## **GARRANE GREEN ENERGY PROJECT COUNTY LIMERICK**

### **N20 / Site Entrance 1 (Temporary) - Junction Design Report**

## **Stage 1 Road Safety Audit**

**Garrane Wind Farm, Garrane, Co Limerick**

### 3.2.2 Construction Stage – N20 Signage

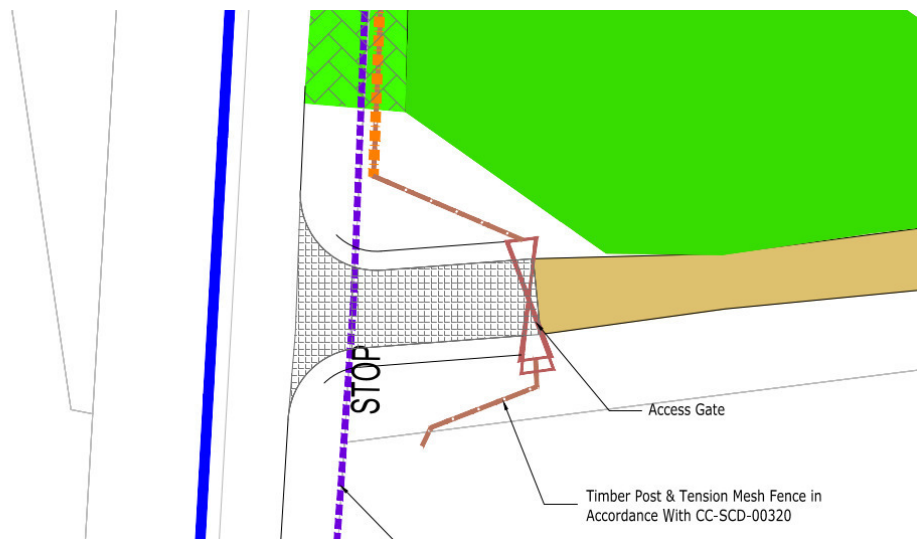
**Problem:** This section of N20 was observed to have a high volume of high-speed vehicles and a high percentage of HGV traffic. The large and heavy vehicles accessing the site are likely to be slow moving when making their turns. There is concern that N20 users will not expect to encounter slow moving vehicles on this straight section of road with historically minimal traffic turning movements.

**Hazard:** Rear end shunt collisions may result.

**Recommendation:** The Design Team should provide temporary signage on the National Road network well in advance of the junction for the duration of the construction phase.

**Note:** All temporary signage should comply with Chapter 8 of the Traffic Signs Manual and be approved by the Roads Authority.

**Design Team Response:** Proposed signage at the N20 site entrance 1 during the construction period is shown on **Figure 6**. Site entrance 1 will be used for the delivery of abnormal loads only. Abnormal load deliveries will take place outside peak traffic hours on the N20 and will be escorted by support teams /

An Garda Siochana who will provide traffic management to allow abnormal load vehicles to access the site.
